ALLEGHENY COUNTY SANITARY AUTHORITY

CONTRACT NO. 1735 G, E, H, P

ALCOSAN PARKING GARAGE

ADDENDUM NO. 1

210-AS-50
ROOM / DOOR SCHEDULES AND DETAILS

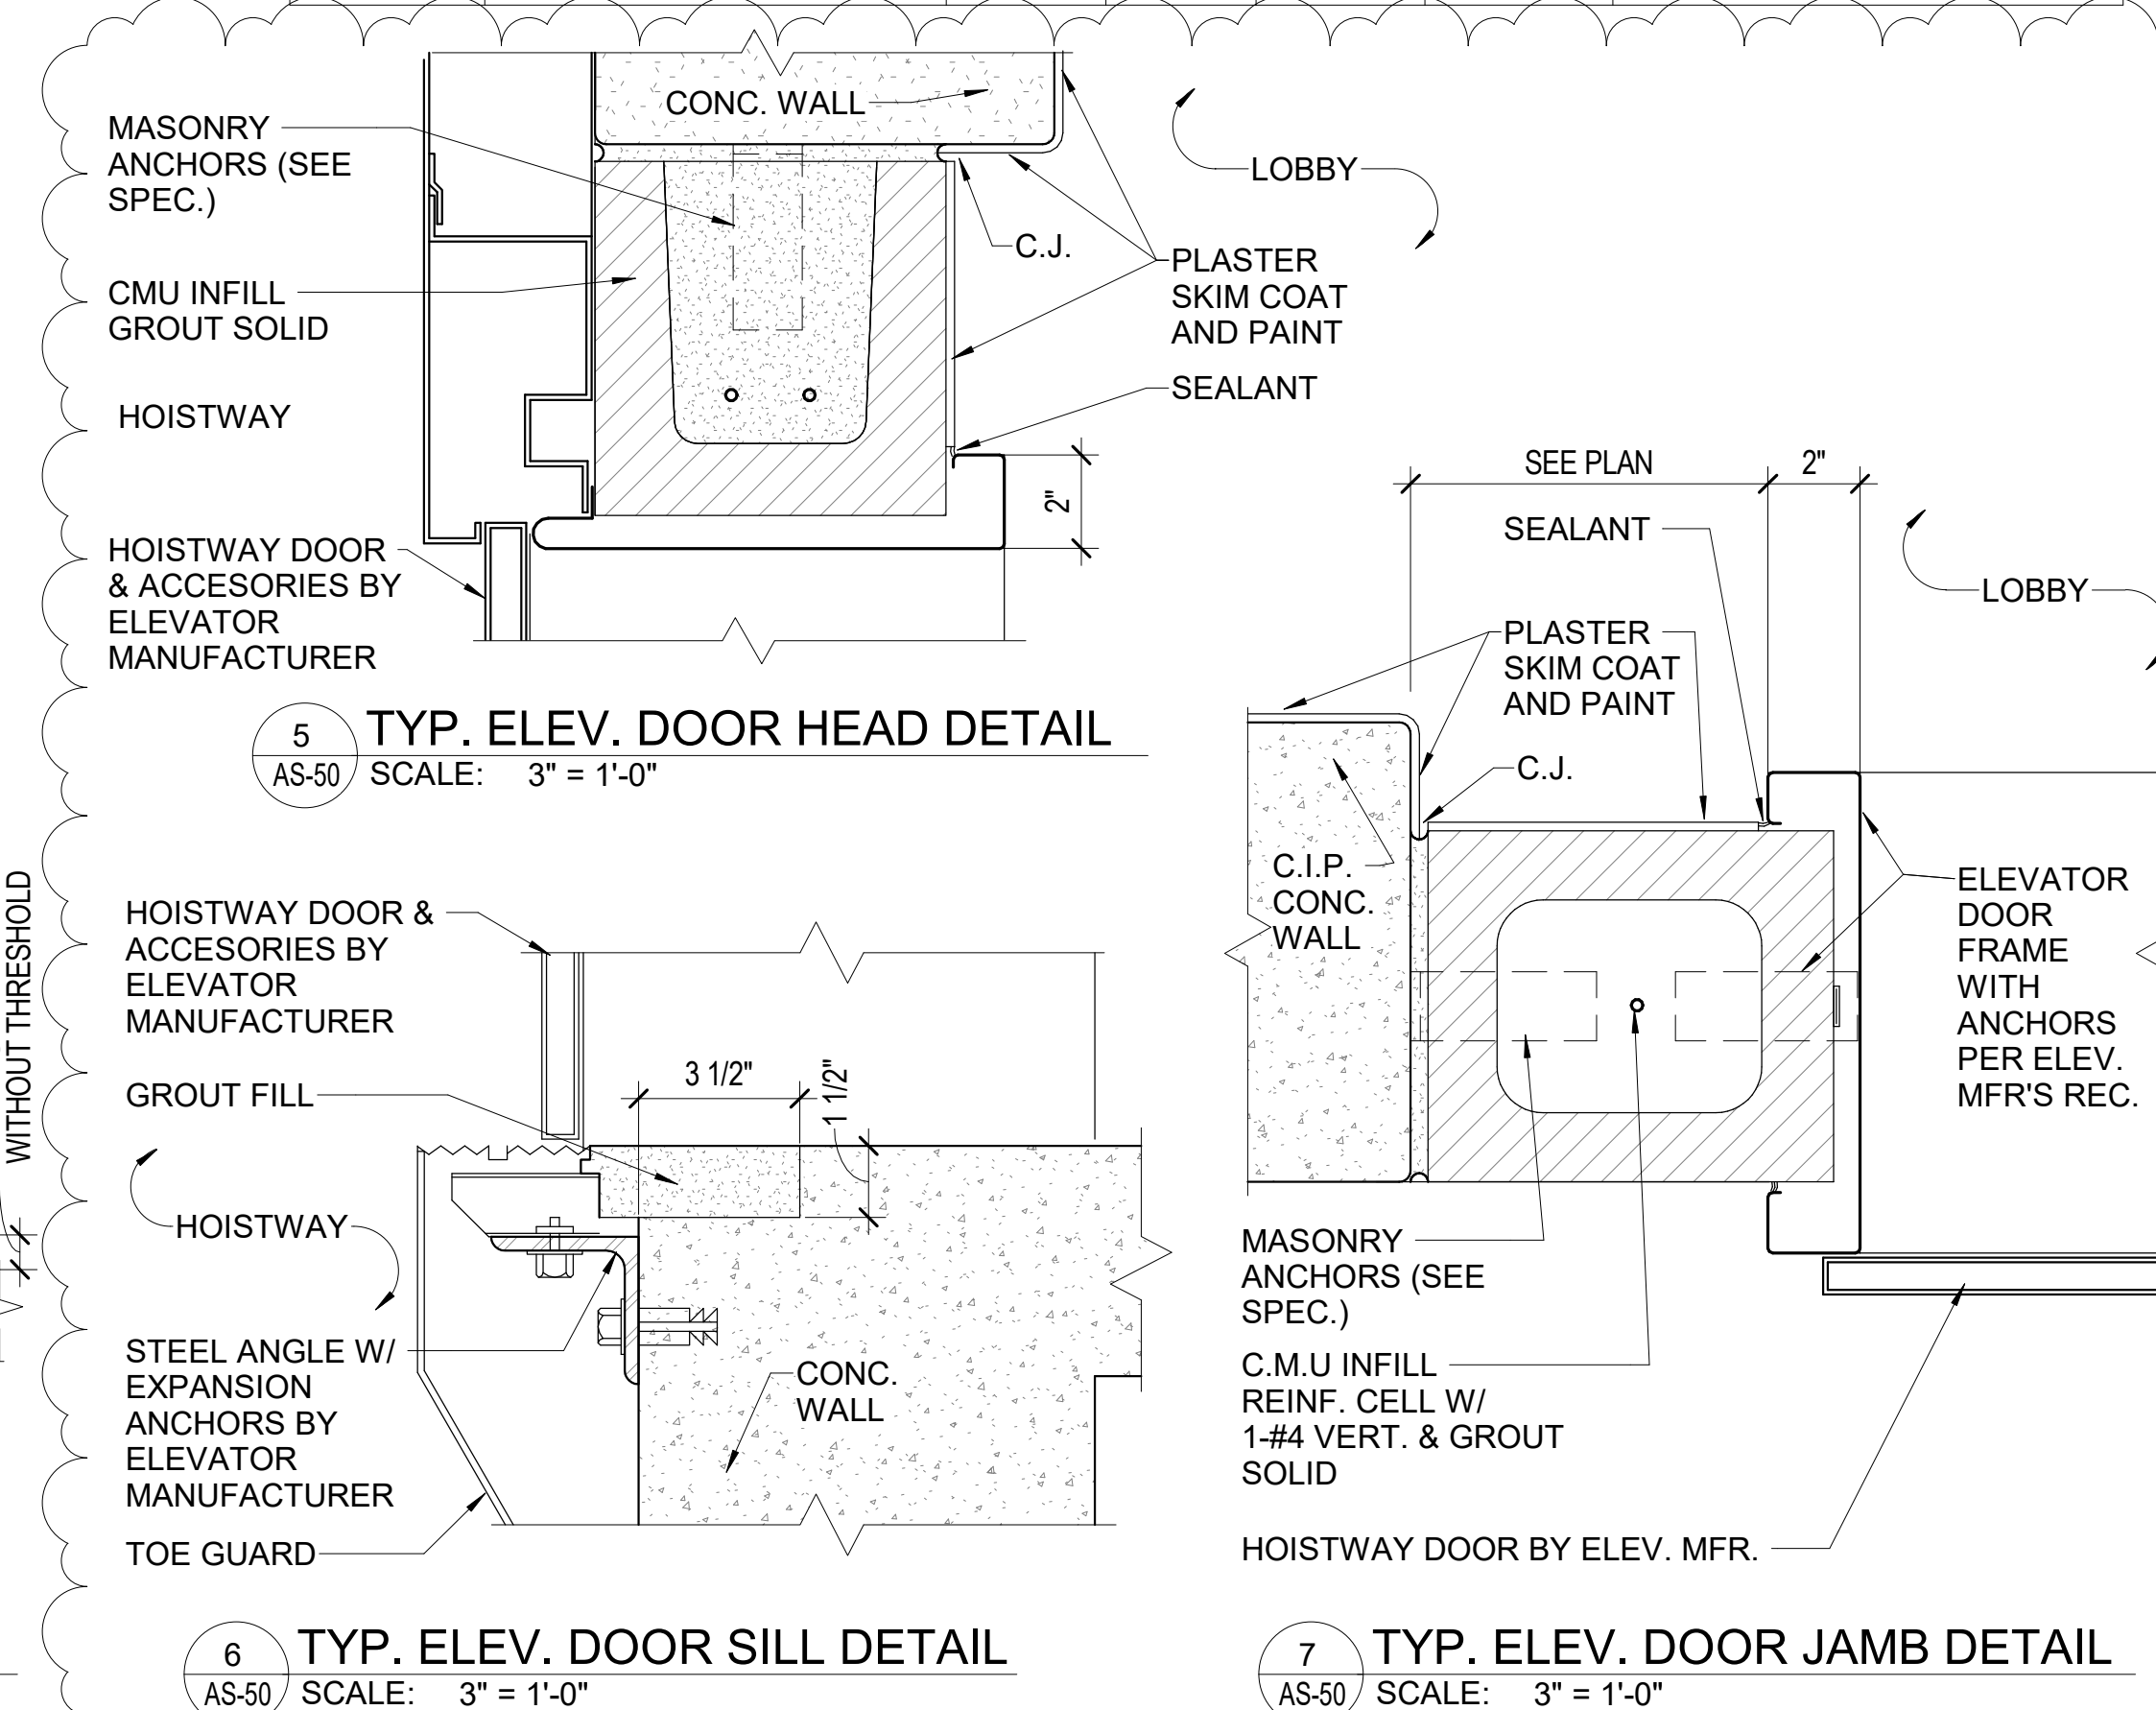
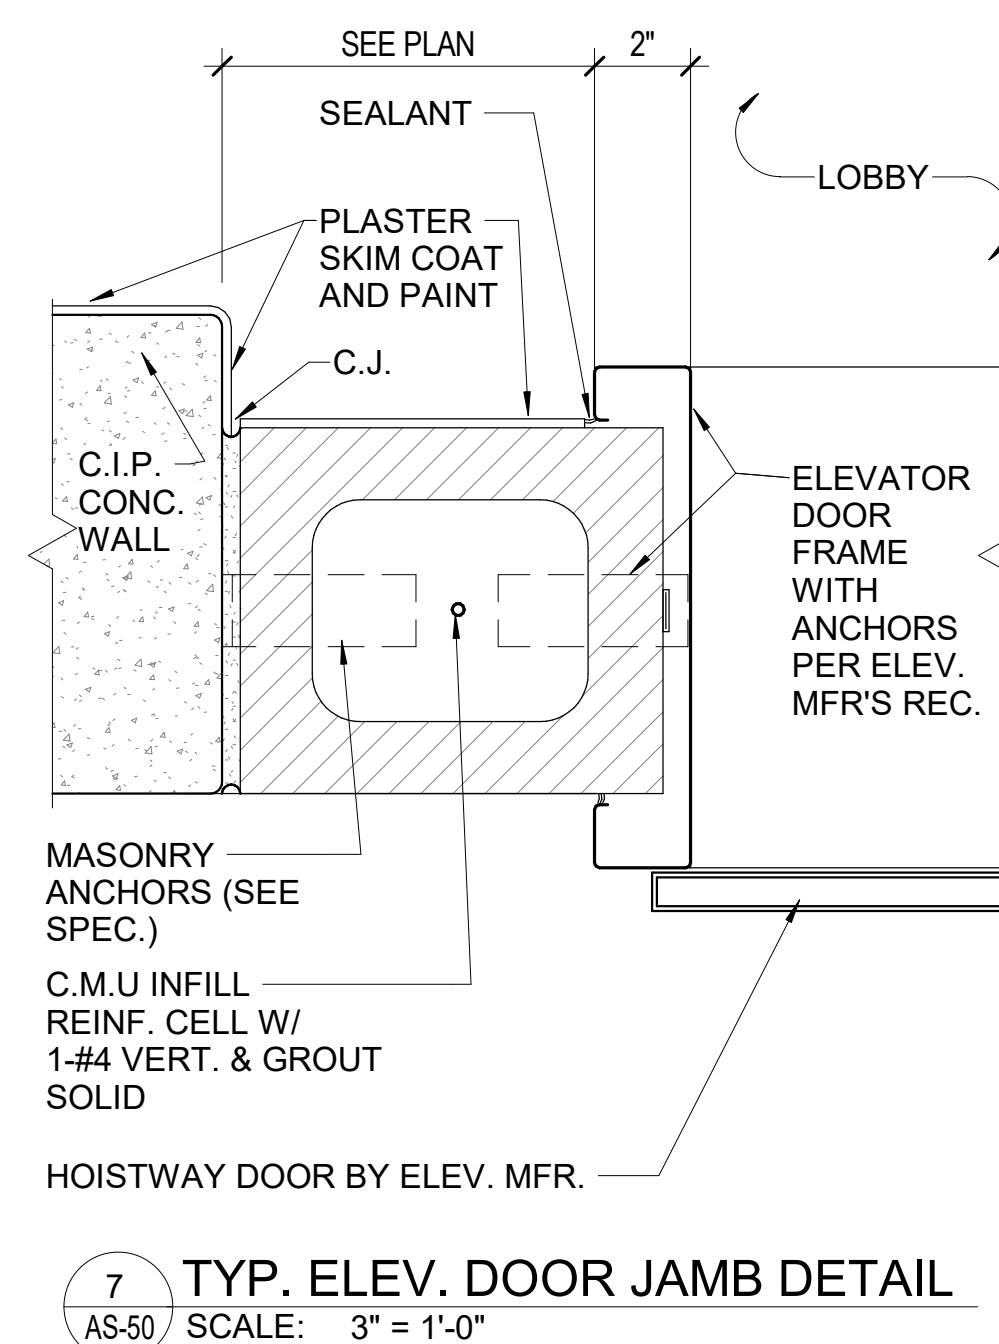
6. Drawing 210-AS-50 Room / Door Schedules and Details:
 - a. REPLACE with the attached drawing 210-AS-50.
 - b. Elevator door details 5, 6 and 7 have been added.

Q12: Drawing A-42, Note 1 (for example): Indicates a “skim coat of plaster.” Please provide a specification for this product and please define the limits of this plaster. For example, the note points to surfaces where the details (such as 1 & 3/AD-71) show masonry with no plaster coating.

A12: See attached section 092400- Portland Cement Plastering. See new details 5, 6 and 7 clouded on attached drawing 210-AS-50.

**210-C-13
PHASE I GRADING PLAN**

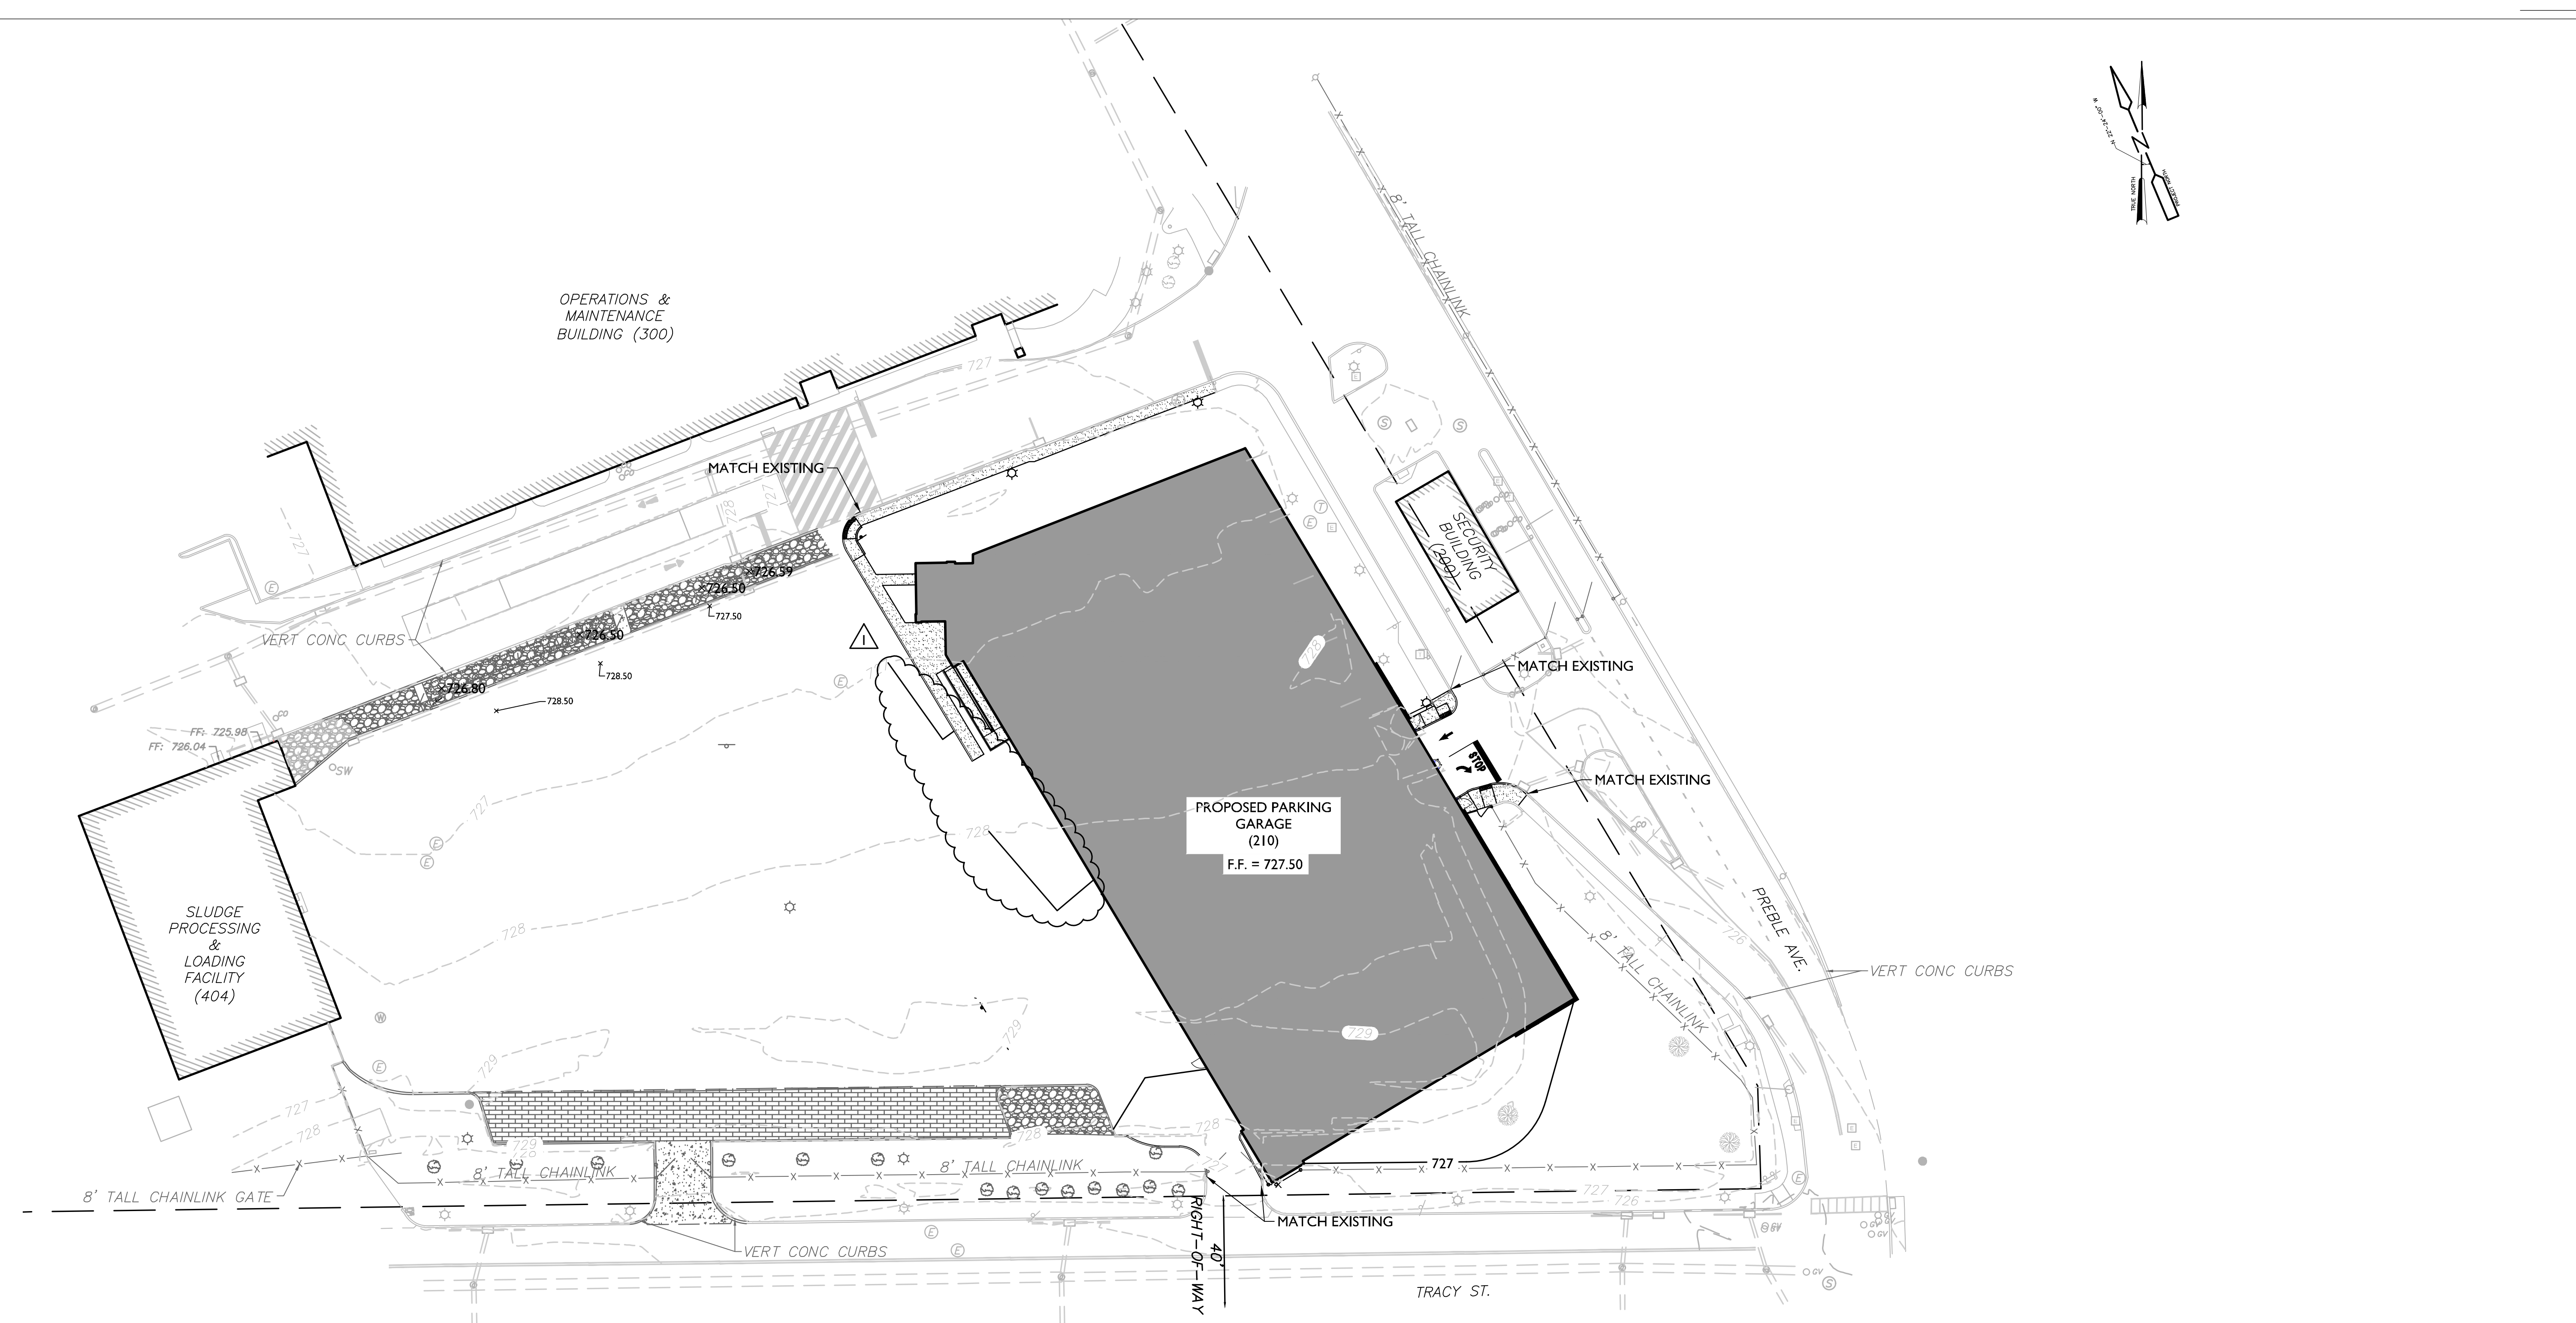
1. Drawing 210-C-13 Phase I Grading Plan:
 - a. DELETE this drawing and REPLACE with the attached drawing 210-C-13.
 - b. Updated grading to keep all disturbed area within the sawcut boundary.
2. Drawing 210-L-101:
 - a. DELETE this drawing and REPLACE with the attached drawing 210-L-101.

Q31: On drawing C-13 there are new contours indicated beyond the limits of the sawcut indicated on drawing C-11. Please modify the sawcut line on C-11 to accommodate the required grading.

A31: Drawing C-11 has been updated.
